December 3, 1985  
Fort St. Vrain  
Unit No. 1  
P-85454

SUBJECT: Fort St. Vrain Control  
Room Design Review  
Summary Report

ATTACHMENT 6b-5

SUMMARY OF THE  
CONTROL ROOM IMPROVEMENT  
DESIGN PROCESS  
AS APPLICABLE TO  
I-03/04

Section of Elevation Drawing  
Showing Original Configuration  
of I-03

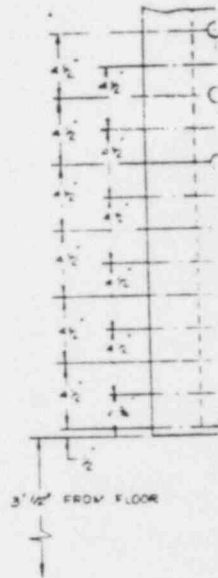
- Delete XI-93128 & NQ-1199.

- Replace function of PI-1151-1, PI-1152-1, PI-1108, PI-1109, PI-1110, PI-1151, PI-1152, & PI-1153 with Reactor Pressure Video Display. Retain analog indicators for displaying reactor pressure channels (PI-1108, PI-1109, and PI-1110).
- Replace NI-1131-1 thru NI-1135-1, NI-1131-2 thru NI-1135-2 with Bar Graph indicators.
- Replace NI-1133-3, NI-1134-3, NI-1135-3, NI-1136, NI-1137 & NI-1138 with digital indicator NI-11100 & selector switch HS-11465.
- Replace HS-93475 thru HS-93478 & XI-93475 thru XI-93478 with single switch HS-93626 & light XI-93636.
- Replace HS-1220, HS-1221, HS-1224, HS-1225, HS-1226, & HS-1245 with group select matrix switch HS-1271-1 thru -14.
- Replace all existing Calico digital indicators with new digital indicators.

- Add PDC-21479 from I-01.
- Add FI-21445 from I-02.
- Add Betaalert annunciator for specific rod withdraw prohibit alarms I-93545.

Section of Elevation Drawing  
Showing Proposed Configuration  
of I-03

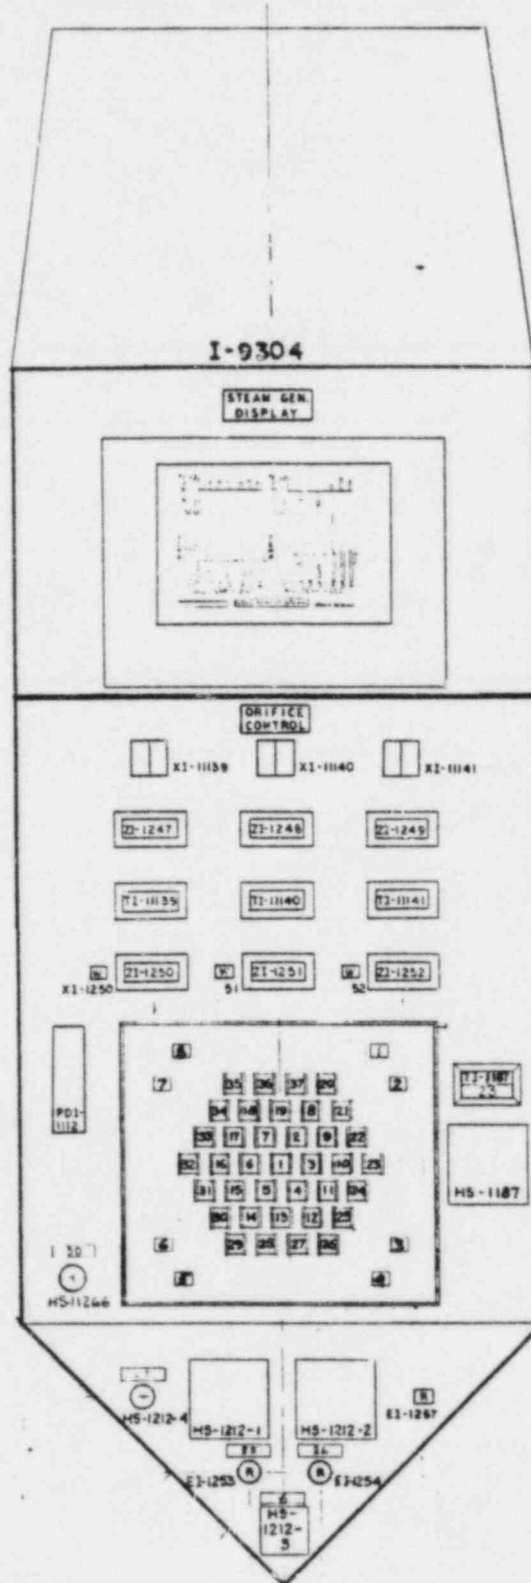
- Delete XI-2222
- Delete XI-22147 & XI-22148.
- Delete XI-1247, XI-1248, & XI-1249.
- Delete XI-11142, XI-11143, & XI-11144.
- Delete HS-22147-1 thru 6 & HS-22148-1 thru 6.
- Delete HS-2222-1 thru -6

- Replace TI-22147, TI-22148, TDI-22147, & TDI-22148 and incorporate function in Steam Generator Temperature & Flow Display.
- Replace all existing Calico digital indicators with new digital indicators.

- Add PDI-1112 from I-03.

Section of Elevation  
Drawing Showing Proposed  
Configuration of  
"Hydraulic Panel"

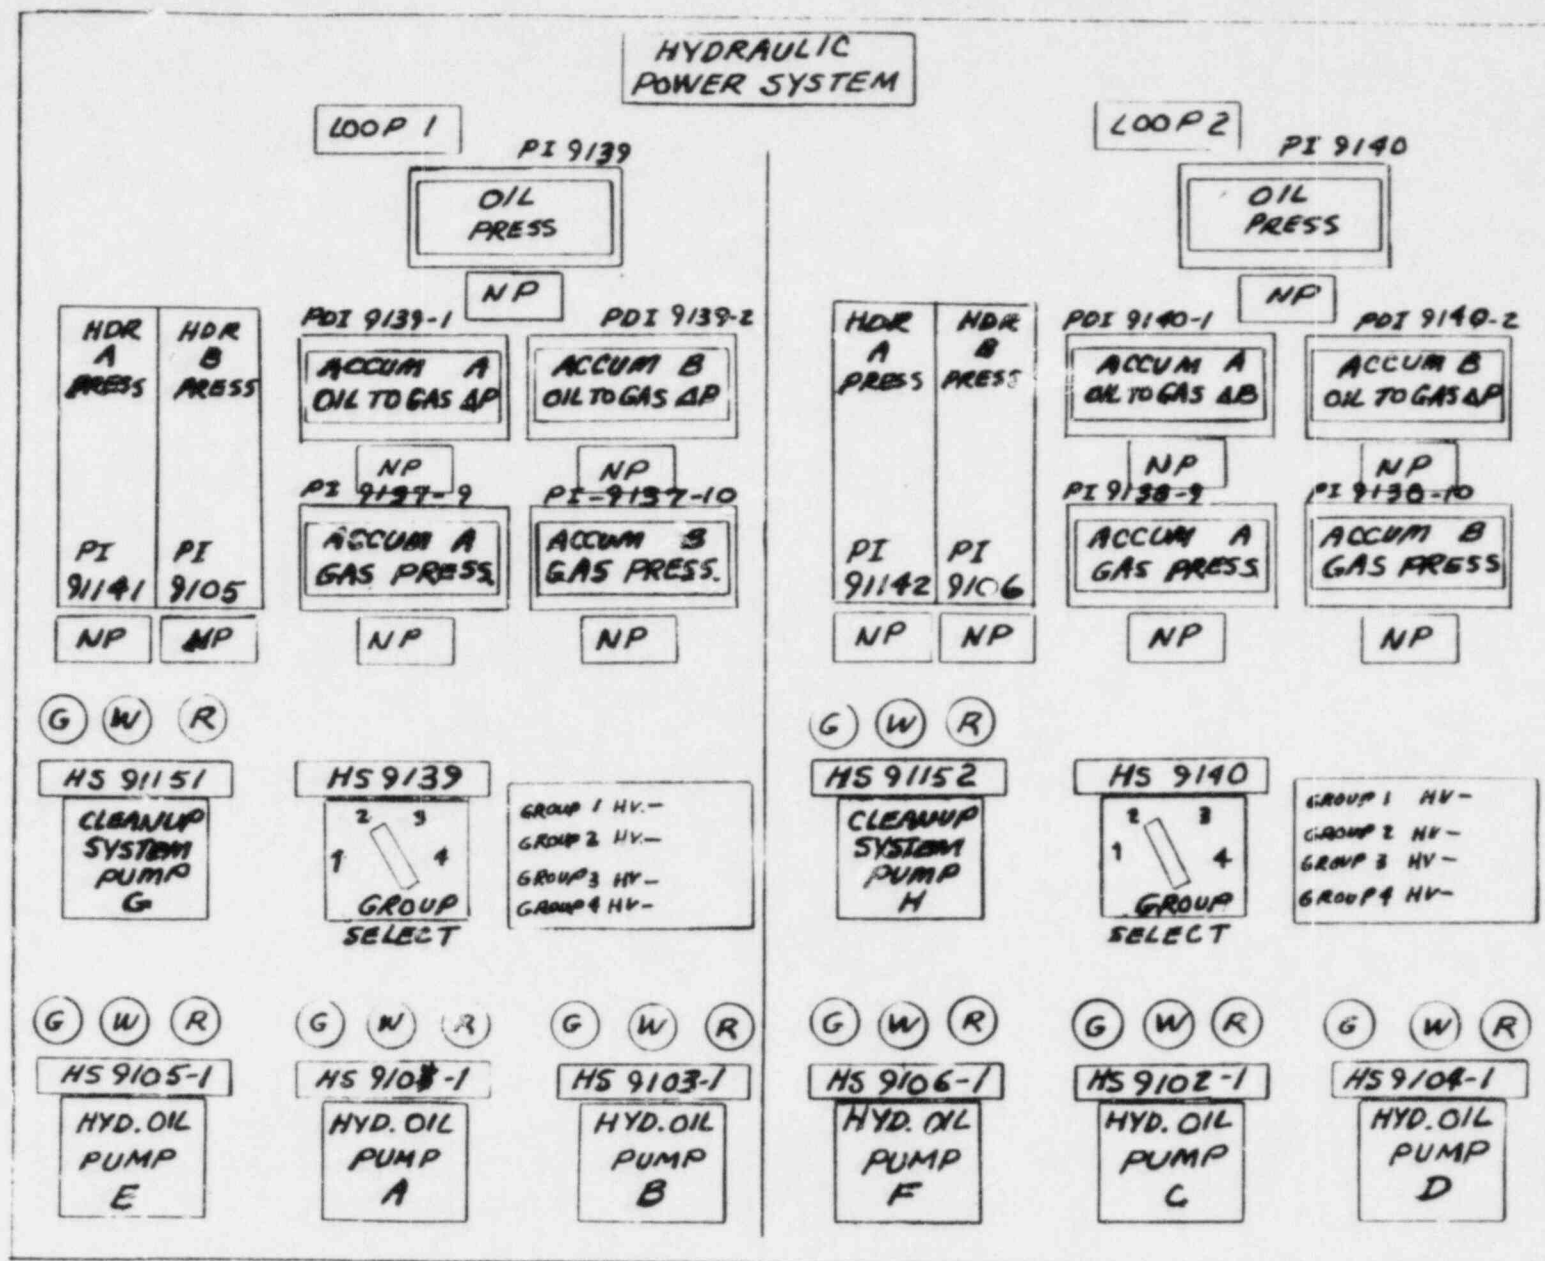
Several minor changes were suggested by respondents during the interviews. These were evaluated and acted on if there was merit in the suggestion. Comparing the enlarged functional group layout sketch used for the interviews with final layout shown in Attachment E, these minor changes are obvious:

- i) changed the pump switch order
- ii) centered the hydraulic oil pressure indicator
- iii) added operator aid legend plate.

EXISTING CONTROL ROOM ARRANGEMENT

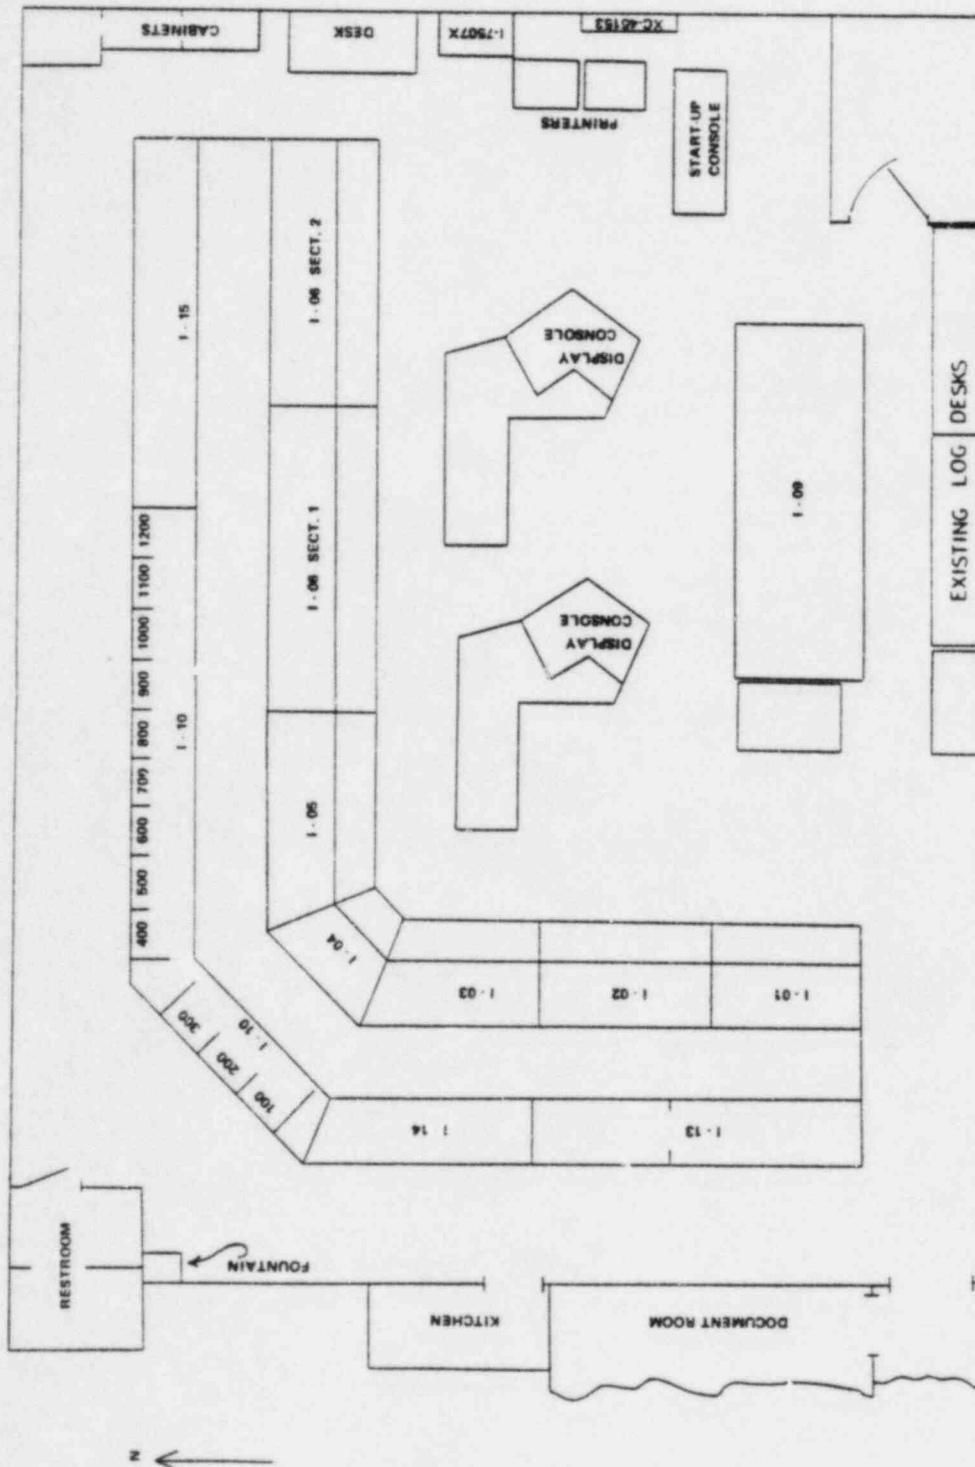
- 12 - Clothing and Hat Storage is random.
  - 13 - Operator desks are cluttered. Furniture arrangement reduces operator space and restricts walkways
- Summary - There does not appear to be dedicated storage for either operational materials or personal belongings. Housekeeping in general is poor. Available space is poorly utilized and maintained.

14. Additional CRT added on an enlarged cabinet at south end of last operator console further restricting operator area & walk-way.
